## **Author's response to Referee #1 (gmd-2023-88)**

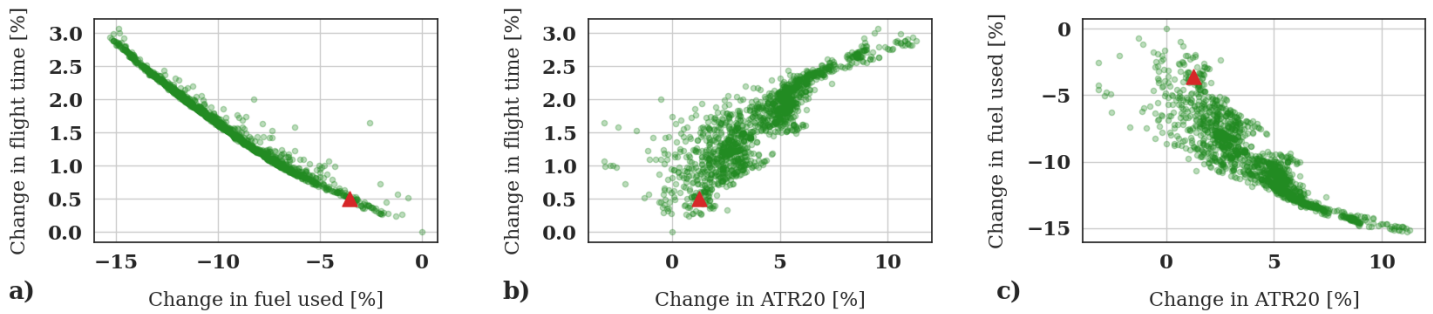
25. *In Figure 4 the red crosses are difficult to see. Perhaps a lighter green could be used for the surrounding markings?*

**Author's response:** Figure 4 has been modified to increase the visibility of the red crosses, as shown below.

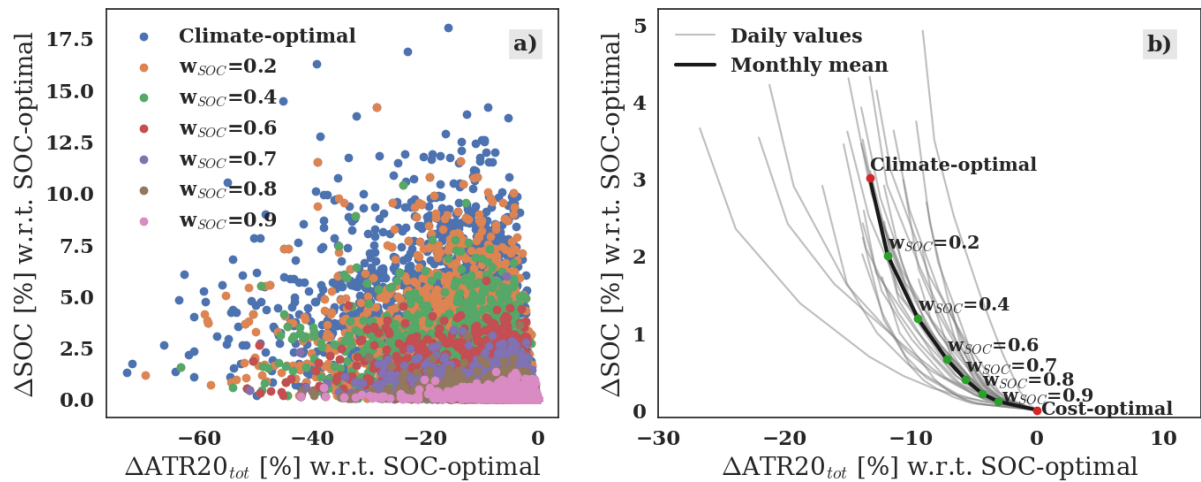
**32.** *Figure 6: Do daily and monthly means have any real value here? If routes are different and days have different atmospheric conditions, averaging removes useful detail from the data. Can data be displayed to show results for each airport pair each day?*

**Author's response:** The daily and monthly means in Figure 6 provide an indication of the mitigation potential of climate-optimal and compromise solutions with respect to cost-optimal solutions, over the considered temporal and spatial domain. The aggregated results can also be more easily compared with previous studies, e.g., Grewe et al. 2017 (see Discussion section). The daily values are also showed in figure 6, to highlight how the relationship between the relative changes in climate impact,  $\Delta\text{ATR20}_{\text{tot}}$  [%], and in simple operating cost,  $\Delta\text{SOC}$  [%], varies depending on the atmospheric conditions. Therefore, these averaged values are useful, and we keep them in the revised version of the paper. However, we agree that meaningful information on the variability over single routes, as we are ultimately interested in specific solutions yielding low cost increase and high climate impact reduction. Therefore, we add a panel in the updated Figure 6 (see below) with the aim of showing the full variability of the data.

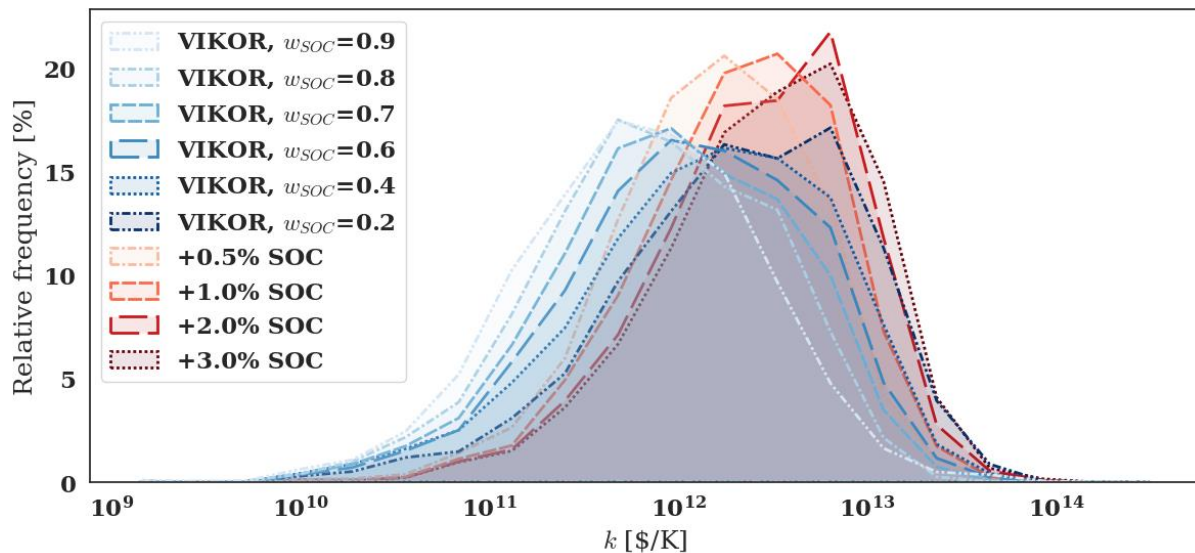
34. Figure 9: Blue lines are too close in colour to differentiate in places. Could the colour choice be extended to make this diagram clearer?

**Author's response:** Figure 9 has been modified to improve its readability. In the updated figure, the style of the lines have been changed, so that curves drawn with two consecutive colours can be better compared by distinguishing their style.
